# RELEASE NOTIFICATION: Configuration Software

## liberoCONFIG & SmartStart version 2021.11.2.0

#### 2.1.1 New option for “Inspection range” added for LIBERO Cx BLE v9.14

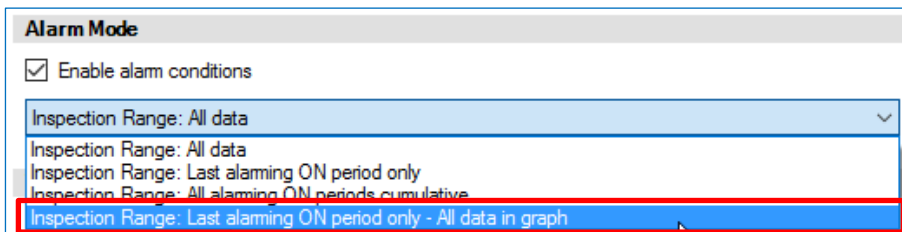
For applications of multiple Alarming ON/OFF periods, a new inspection range option “Last alarming ON period only – All data in graph” puts focus of alarm statistics on the last alarming ON period only, while the logging results graphic in the PDF report shows all data since last start of the logger.

#### 2.1.2 New option “Stop disabled” added for LIBERO Cx BLE v9.14

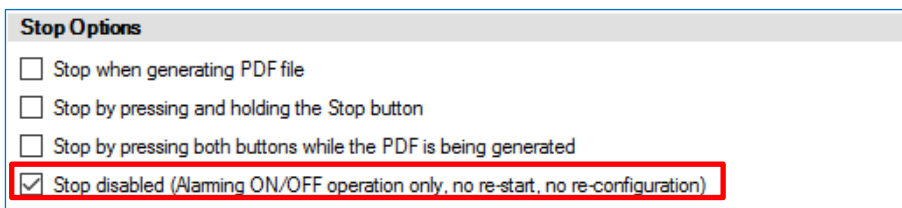
LIBERO Cx BLE devices are logging measurement values after start of the logger until the device is stopped. At time of re-start, data in memory is removed in order to enable the full memory capacity for the next logging period.

A new option “Stop disabled” is preventing a stop of the logger, but enables constant logging with flexible use of alarm activation (alarming ON/OFF).

Note: when applying this stop mode the device can not be re-started or re-configured.
